REVISED
PLAN COMMISSION
MEETING NOTICE AND AGENDA
Thursday, March 18, 2021
7:00 PM
VIRTUAL ONLY

Discussion and Action Regarding a Recommendation to the Common Council for a Conditional Use Permit and Site and Building Plans for Zeilhofer Properties, LLC for Property Located at N4 W22540 Bluemound Road for the Purpose of Constructing a New Freestanding Two-Story Storage Building (PWC 0963997)

Date: February 15, 2021 (3/8/21 - A/E Comments in RED)
To: Mark Wershay, Zimmerman Architectural Studios, Inc.
From: Nick Fuchs, Planner & Community Development Director
RE: Zeilhofer storage building Conditional Use and Site & Building Plan Review

2 Upper Level Floor Plan

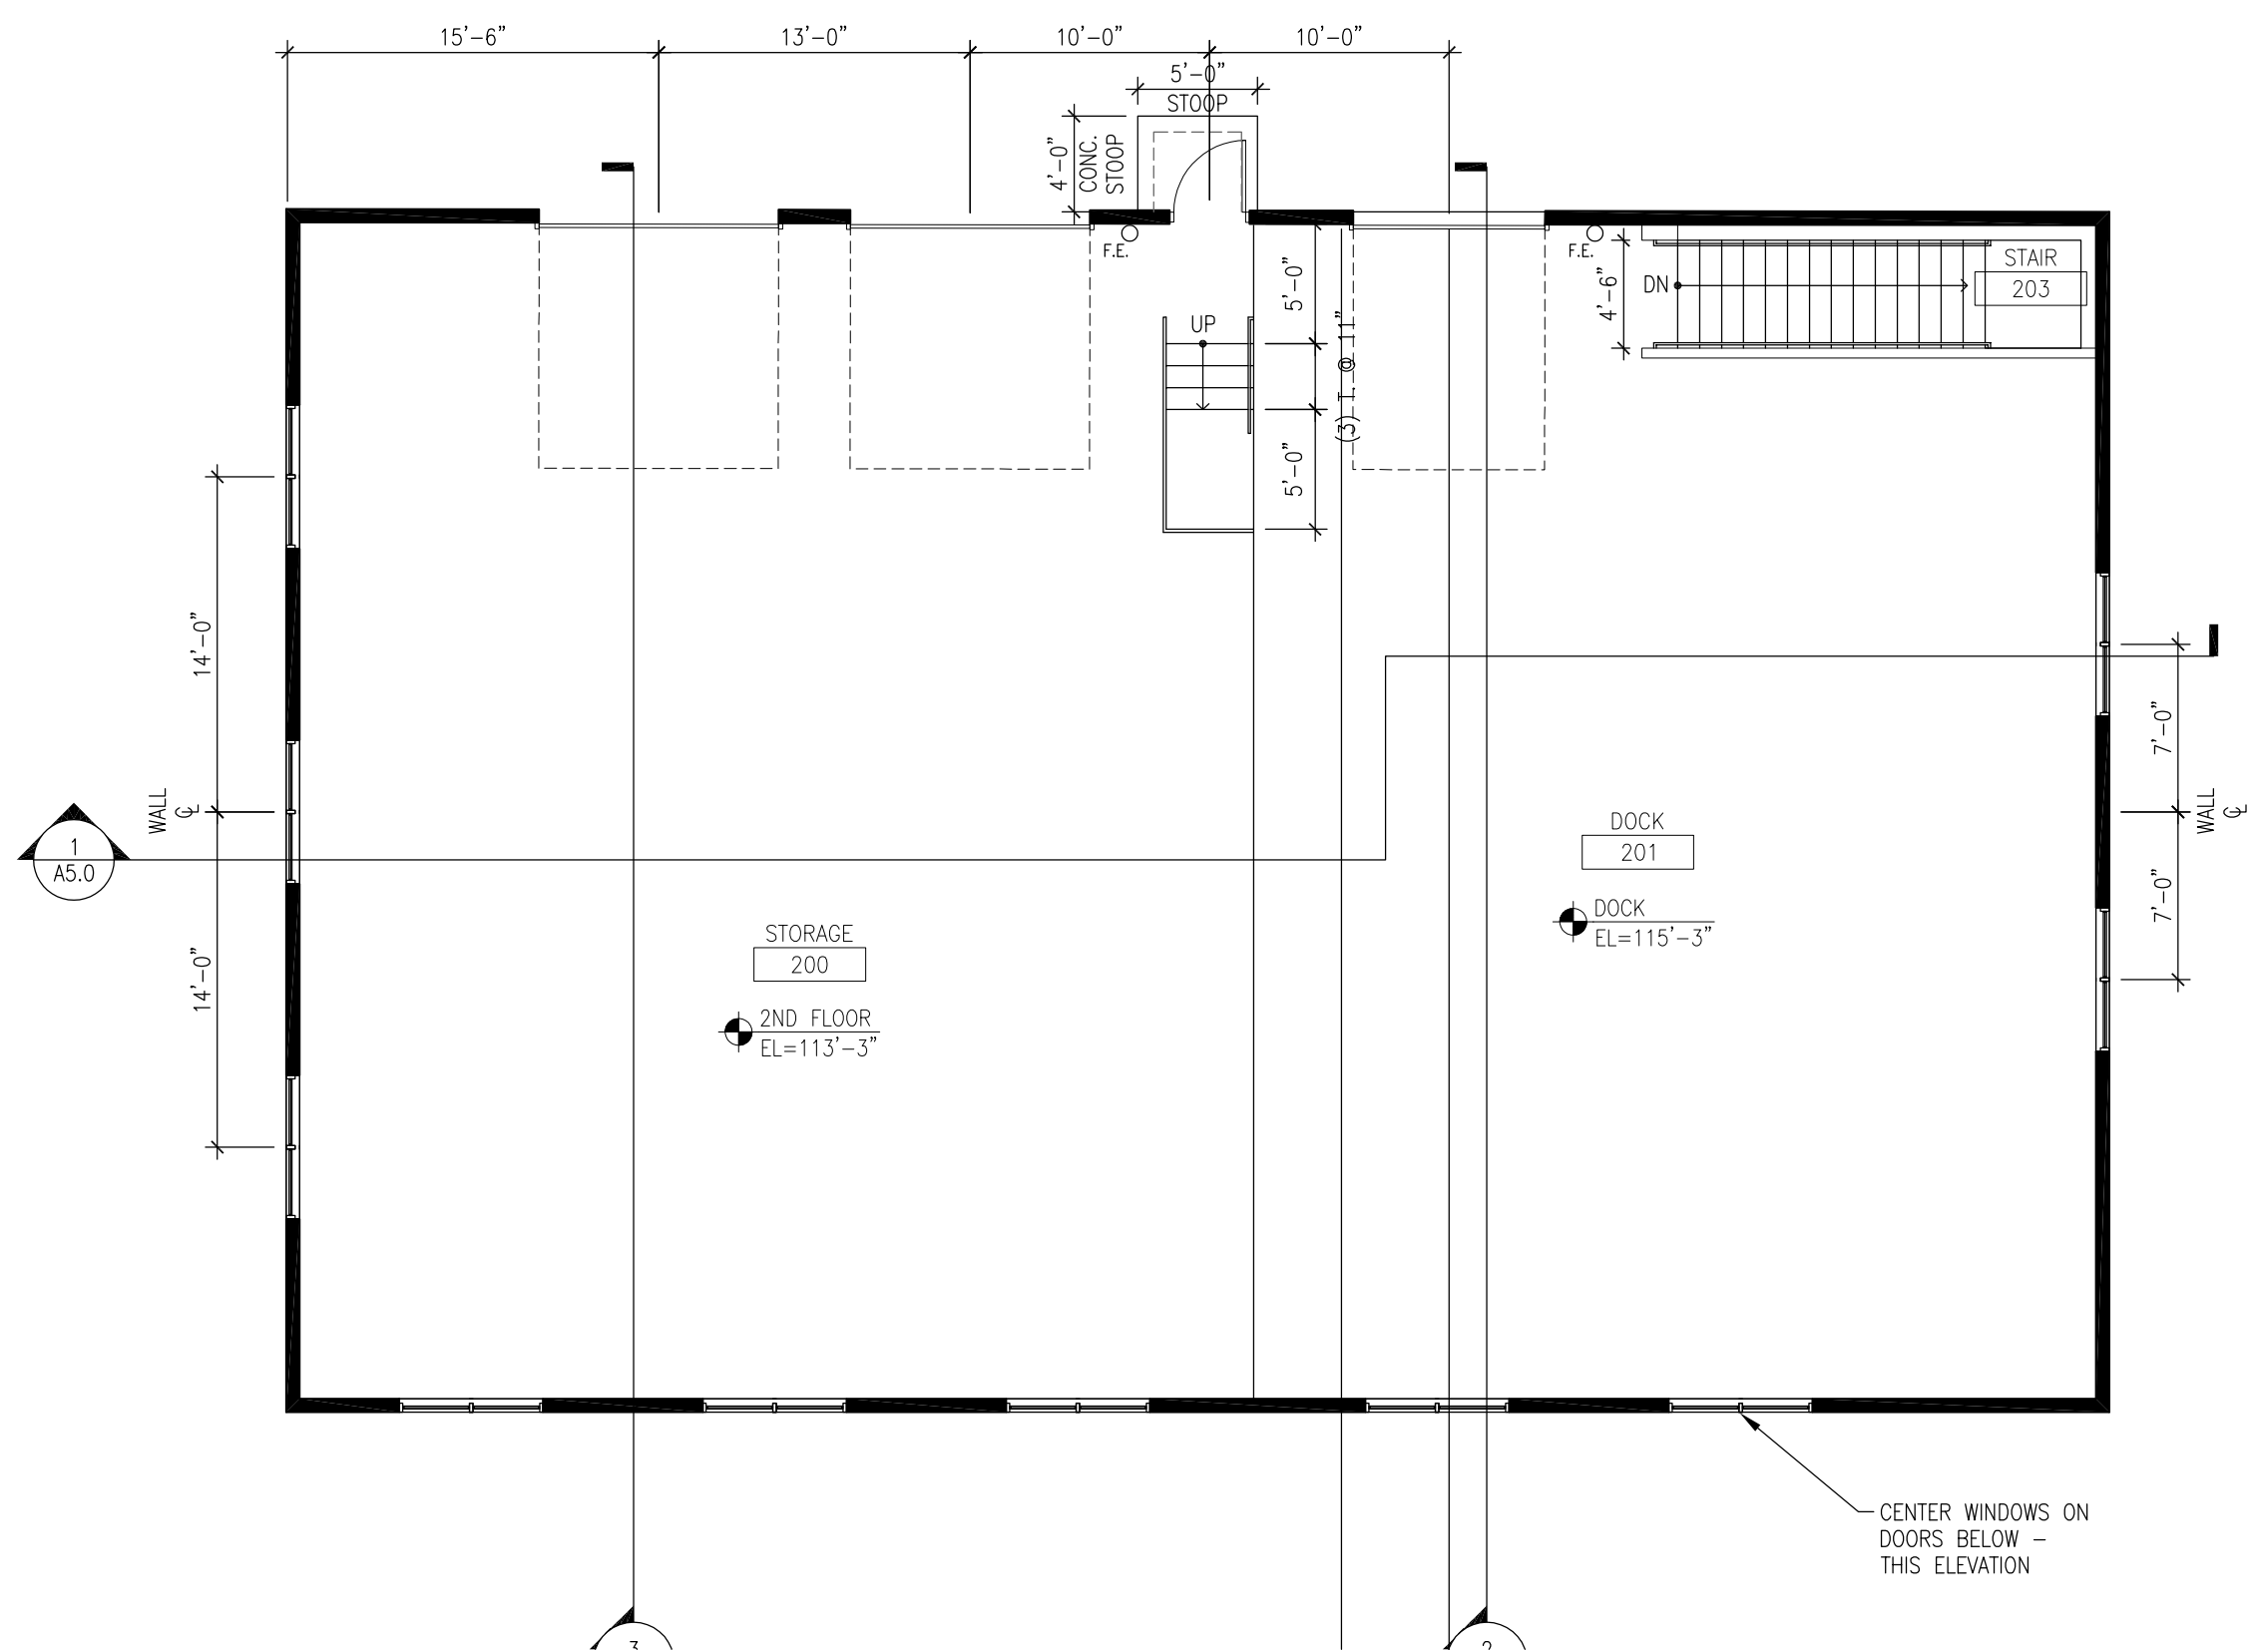
8. What color will the CMU foundation be painted? **Charcoal.**
9. What type of roof material is being used? **Standing seam metal roof as noted on the plans.**

Schematic
Landscape Plan

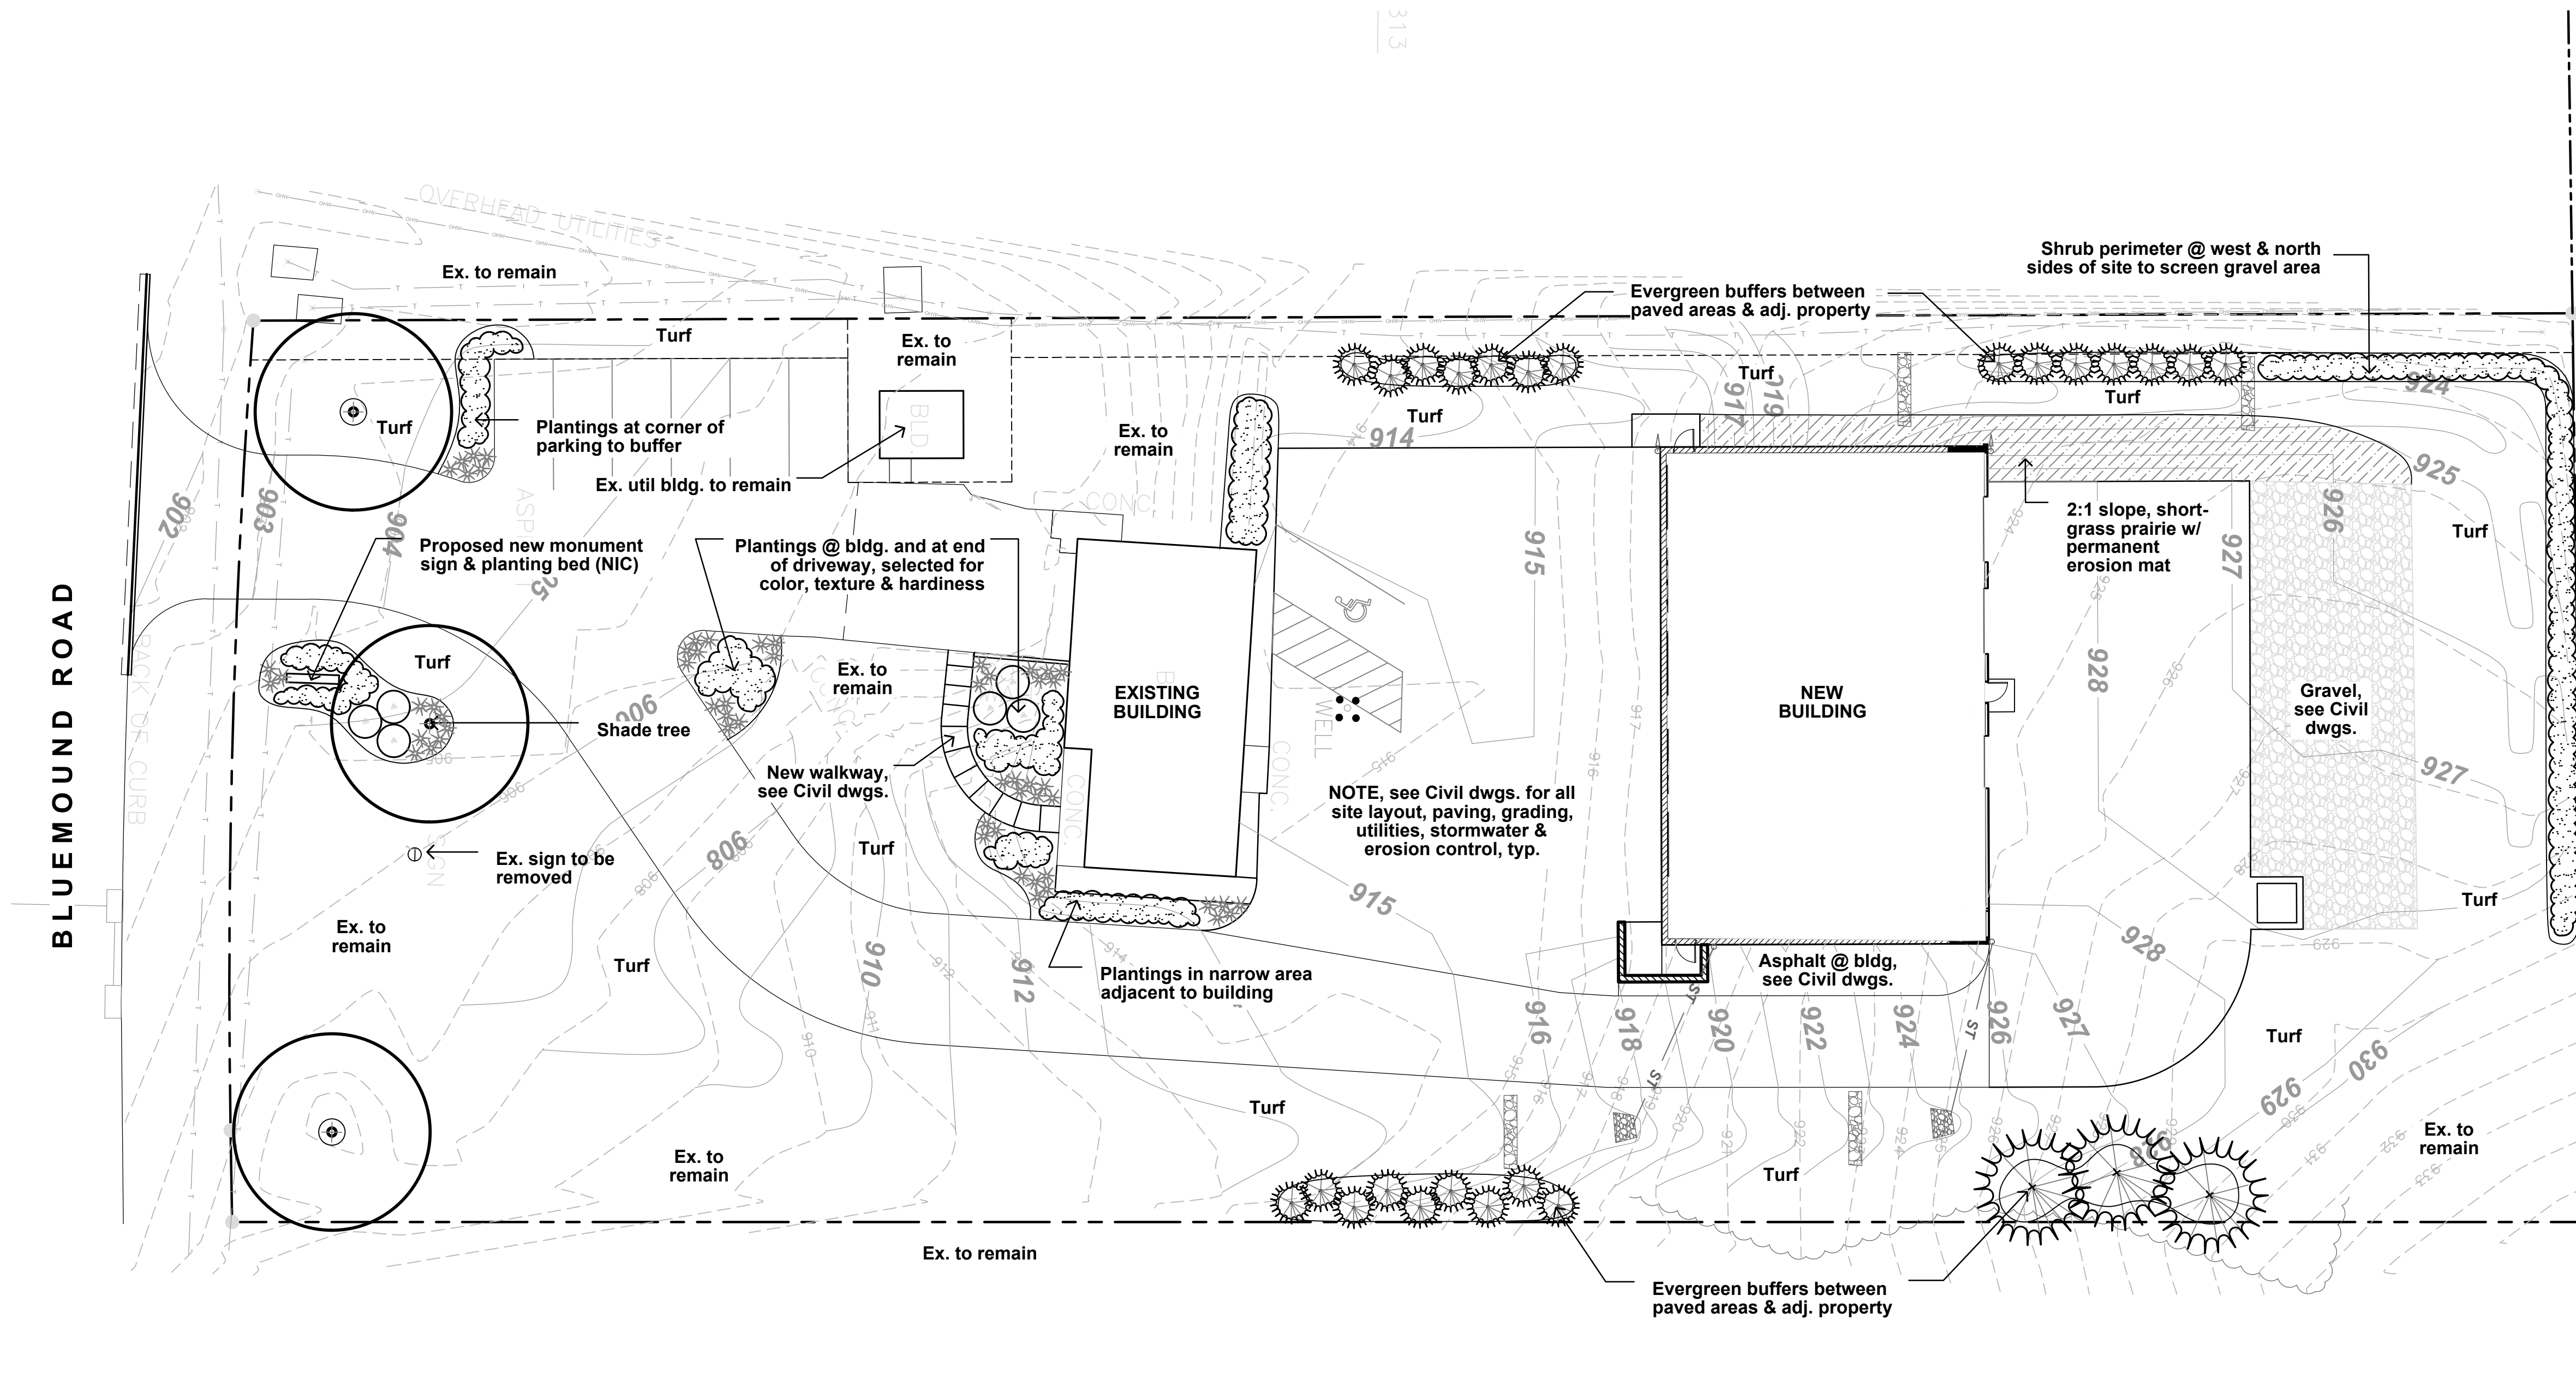
11. There does not appear to be grading around the two 18" trees in southeast corner of the site and minimal grading around the 60" tree. Why are these trees being removed? It is recommended that all three trees be preserved. **All three trees are not in good health or aesthetically appealing. A portion of the 60" trees root system will need to be removed when putting in the drive which will place a declining tree in further decline. This large tree has a low crotch making it susceptible to failure. A much more appealing linden tree is planned for the SE corner where the two 18" trees would be removed.**
